SUBJECT: Forwards util responses to NRC 800207 questions re dedicated shutdown sys,Graphs & fire protection drawings encl.

H. B. ROBINSON STEAM ELECTRIC PLANT UNIT NO. 2
DOCKET NO. 50-261
LICENSE NO. DPR-23
DEDICATED SHUTDOWN SYSTEM

S5. Clarify the discrepancy between the first and fourth paragraphs of FSAR page 8.2-13 with regard to the transfer of loads from one diesel generator to the other.

FIGURE 58-1
SERVICE WATER DISCHARGE VALVE V6-12D

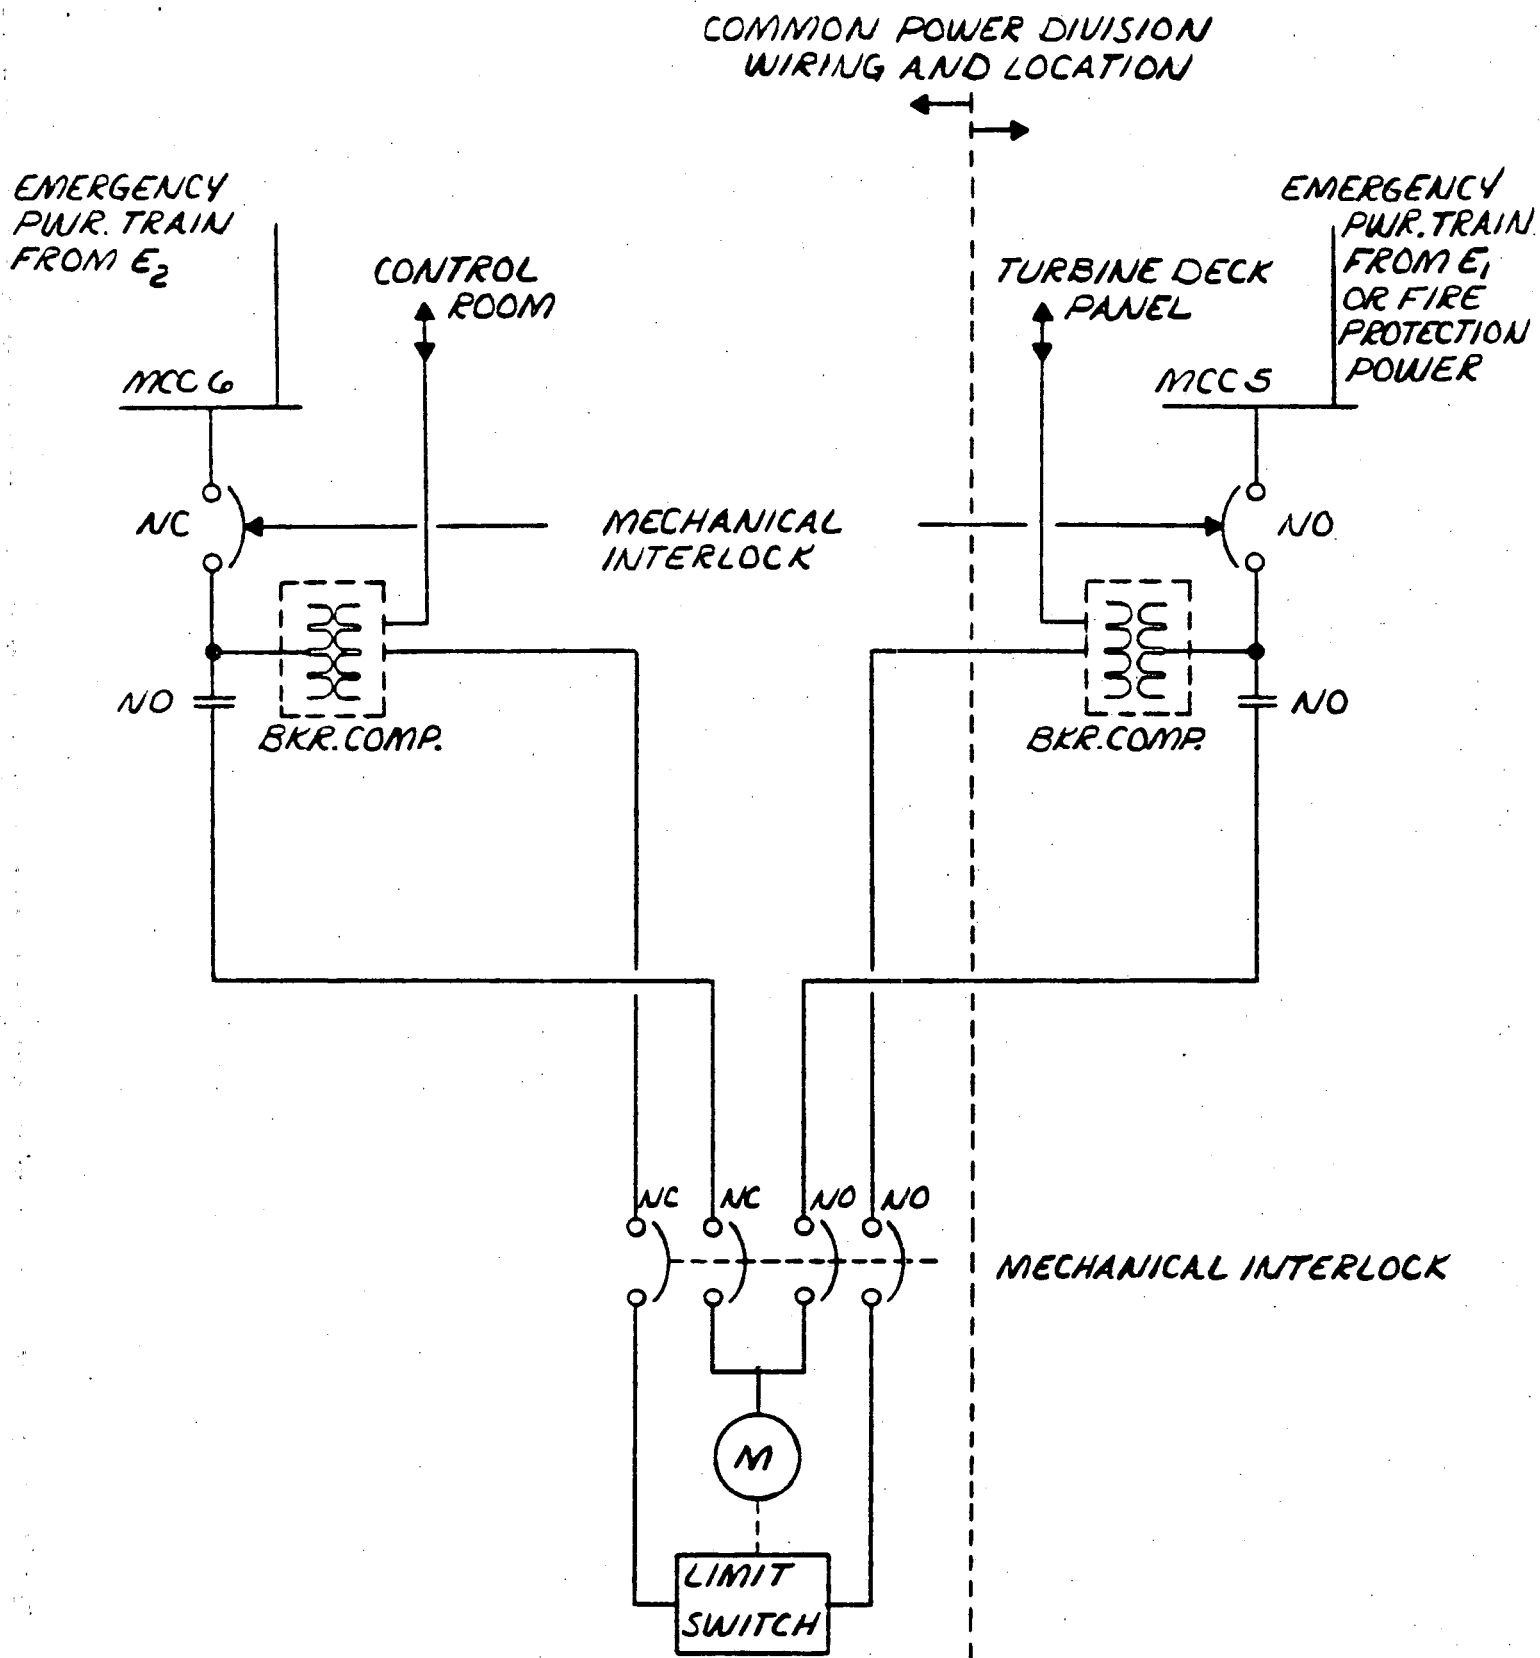
S8. The discussion of the single failure criterion, on page 12 of your February 1, 1980 submittal, states that your "modifications generally affect only one of redundant equipment trains." Identify and justify all exceptions to this general rule.

In accomplishing the referenced modifications, in only one case were redundant safety-related equipment trains modified; this occurred in providing a redundant power and control configuration for service water discharge valve V6-12D (refer to Figure S8-1).

Alternate power source connection to MCC 5 or MCC 6 is now possible, thus interfacing both power divisions with a single device. However, simultaneous connection of both sources to the valve circuit is prevented by means of a mechanical interlock on the MCC circuit breakers. (One breaker must be tripped before the alternate power source breaker can be closed.)

As valve V6-12D is presently configured, the independence of safety-related power sources MCC 5 and MCC 6 is not compromised.

CAROLINA POWER & LIGHT COMPANY H.B. ROBINSON STEAM ELECTRIC PLANT	
STEAM DRIVEN FWP STEAM SHUT OFF VALVE VI-8A	
CP+L SH 1033	
NUS CORPORATION	5137-E-6101 2
SCALE NONE	SHEET 1 OF 3

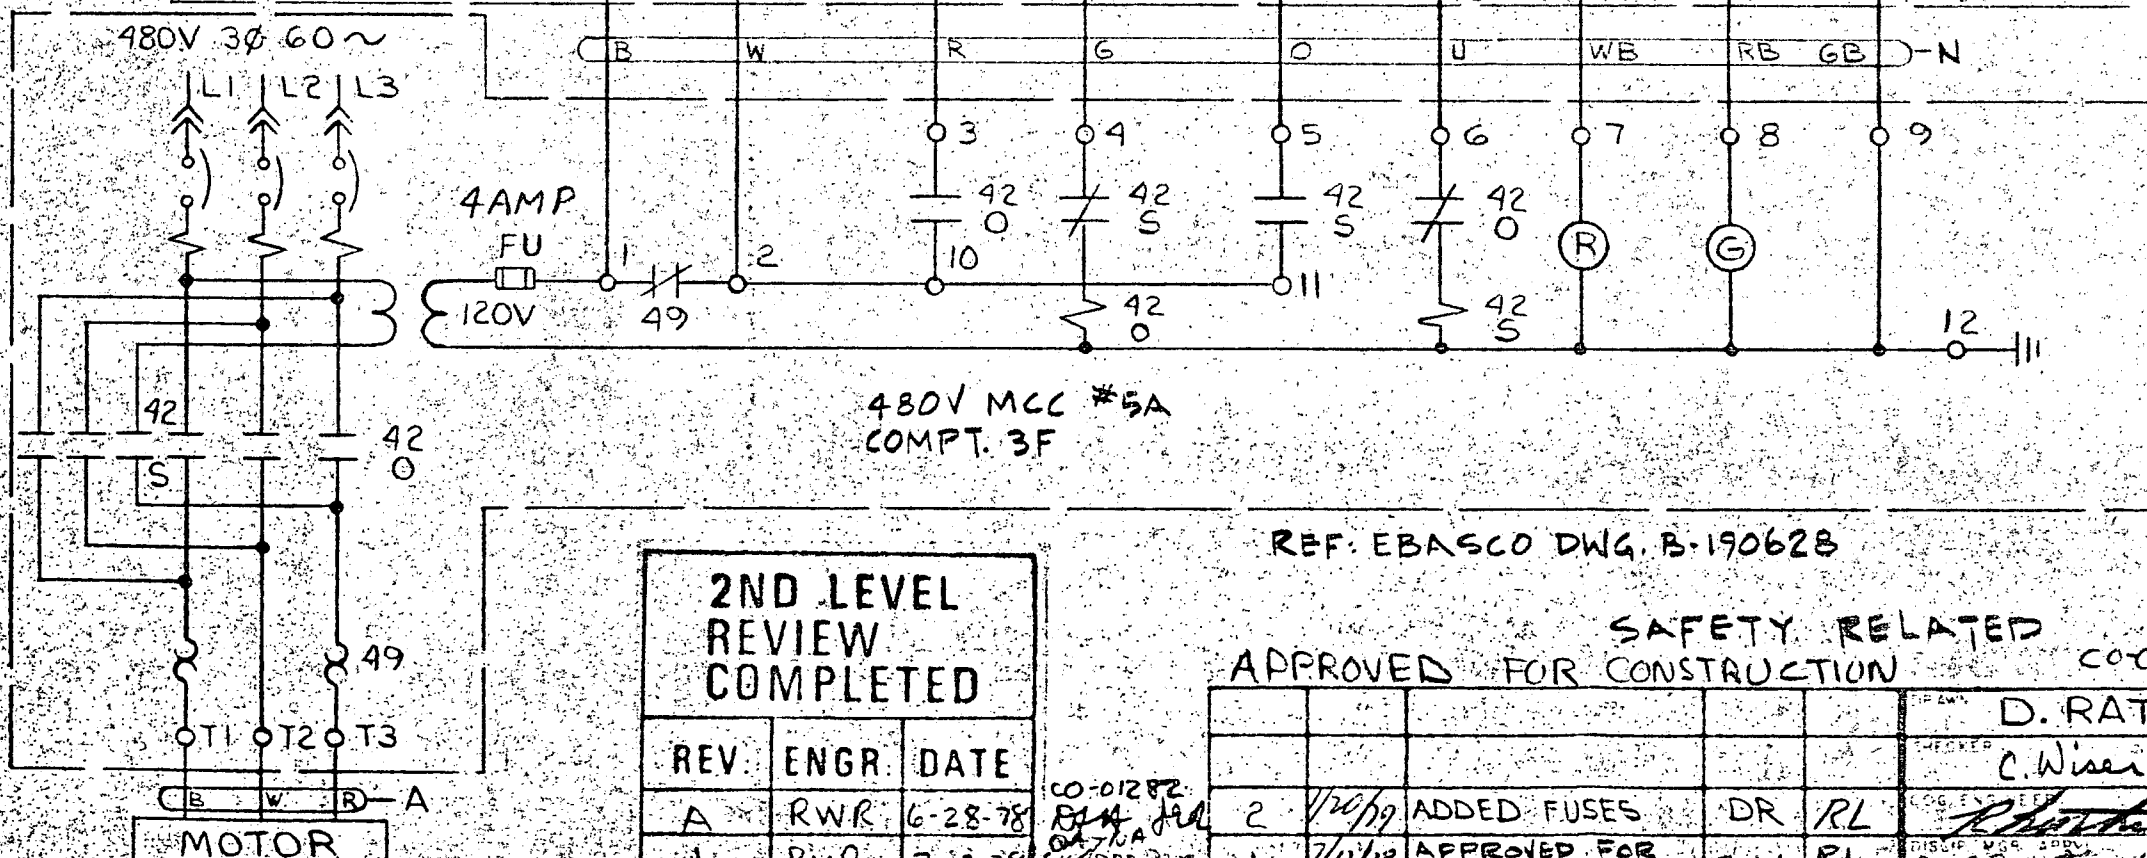
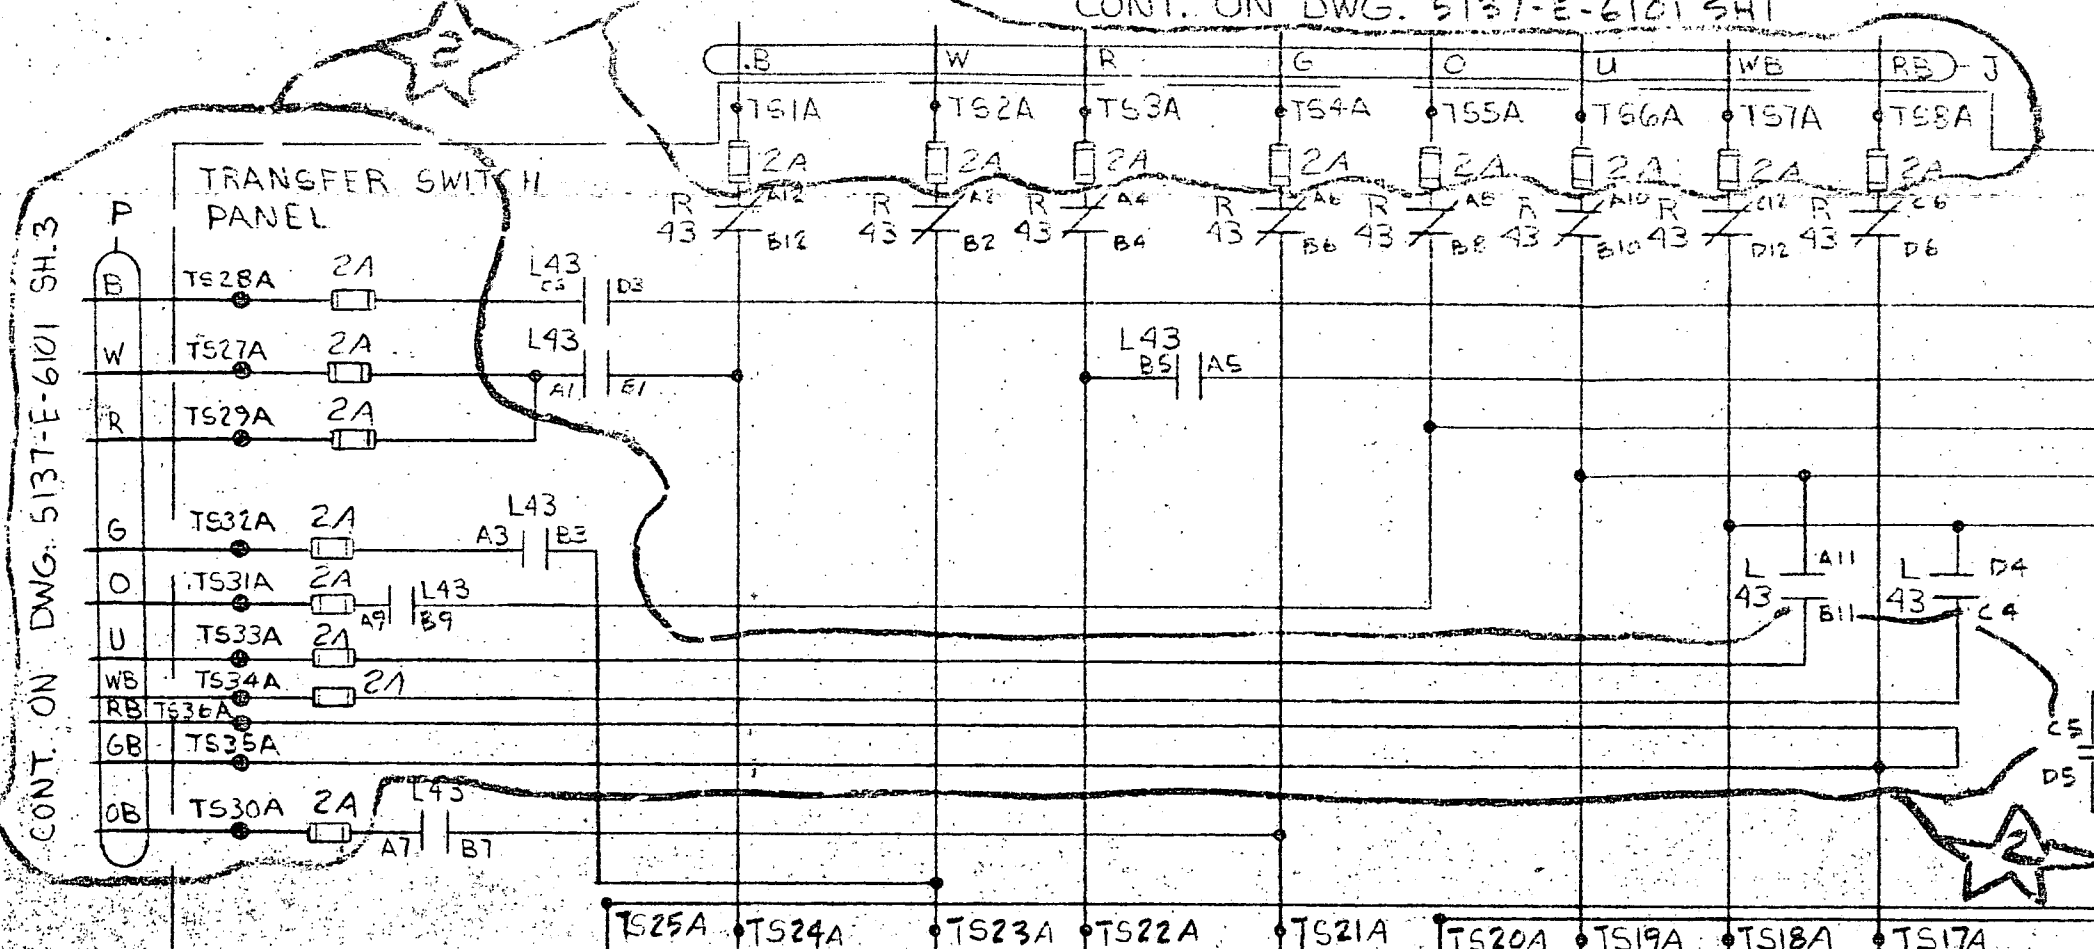
S12. With regard to Figures 2 and 3, in the February 1, 1980 submission, explain why fuses were added to the limit switch circuits in the local position but not the remote even when fuses were added to both local and remote circuits of the other motor controls.

Valve V1-8A: Drawings No. 5137-E-6101, Sh. 1-3

With the valve control selector switch in the "remote" position, the only interface between the limit switch and the motor control center is through the main control panel and the transfer switch panel. The associated conductors are each provided with protective fuses.

Consequently, fuse protection is provided for the limit switch circuits in both the local and remote control modes of operation.
